CAA Decision Log

Title of Airspace Change Proposal (ACP)	Enabling Remotely Piloted Air System Operations at RAF Fairford - HALE
Airspace Change Proposal Reference	ACP-2021-078
Change Sponsor	Ministry of Defence (MoD)
AIS Submission Target Date	Submission Date: 16 February 2024 for AIRAC 05/2024
CAA Decision Target Date	16 February 2024
<p><i>Instructions</i></p> <p>In providing a response to each question and/or status, the following colour coding should be used:</p> <p>COMPLIANT/NOT APPLICABLE</p> <p>NOT COMPLIANT/ACTION REQUIRED</p> <p>ISSUE/CONCERN TO HIGHLIGHT</p>	
Executive Summary	
<p>The original intent of this ACP was to establish suitable airspace structures in the vicinity of Royal Air Force (RAF) Fairford to enable the operation of the United States (US) Air Force's High Altitude Long Endurance (HALE) and Medium Altitude Long Endurance (MALE) Remotely Piloted Aircraft (RPA) from the unit. The US RPAs do not have a CAA-approved Detect and Avoid (DAA) capability to operate beyond visual line of sight (BVLOS) in UK airspace. Therefore, suitable airspace structures are necessary to enable the transit of US RPAs through the UK airspace before reaching the desired operational

Figure 3 – Proposed Amendment of EGD218 C & D (Upper Altitude to FL660)

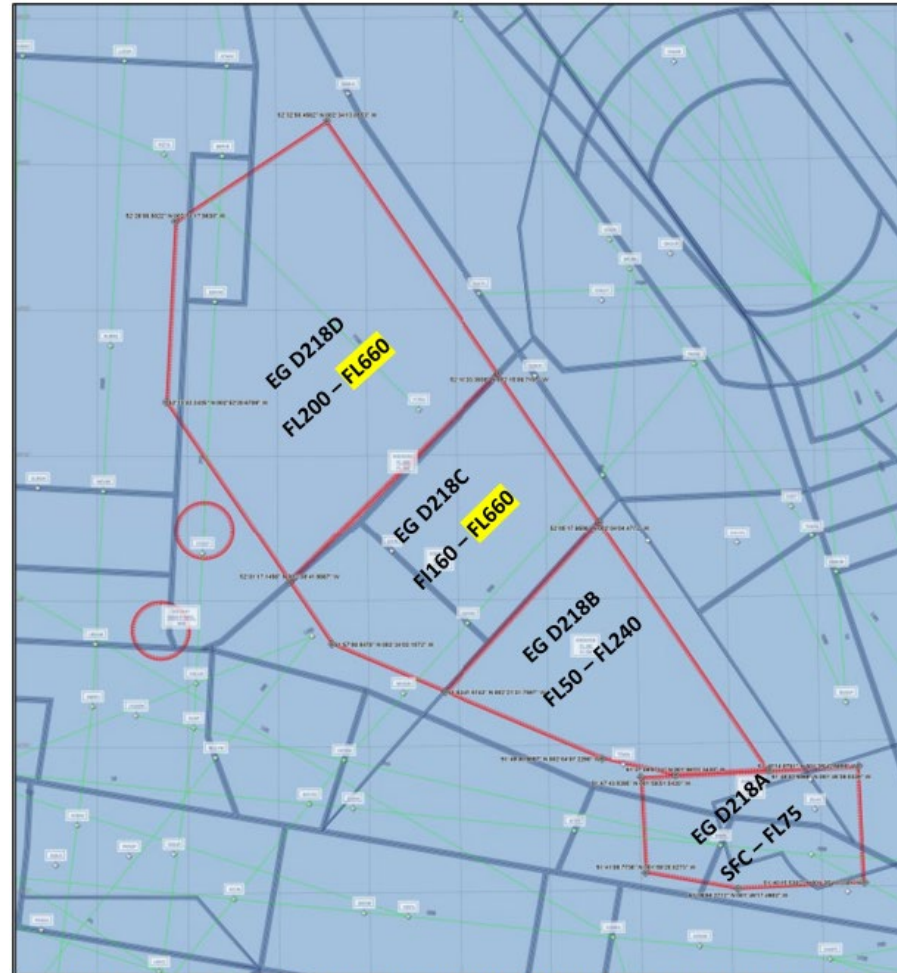
Technical Amendment: Following a request by the CAA to the sponsor for clarification in relation to onwards operations, the sponsor was asked to consider a technical amendment to the airspace design. That amendment sees the upper level of the DA complex (segment C and D) rise to FL660 rather than FL500 as stated in the final submission.
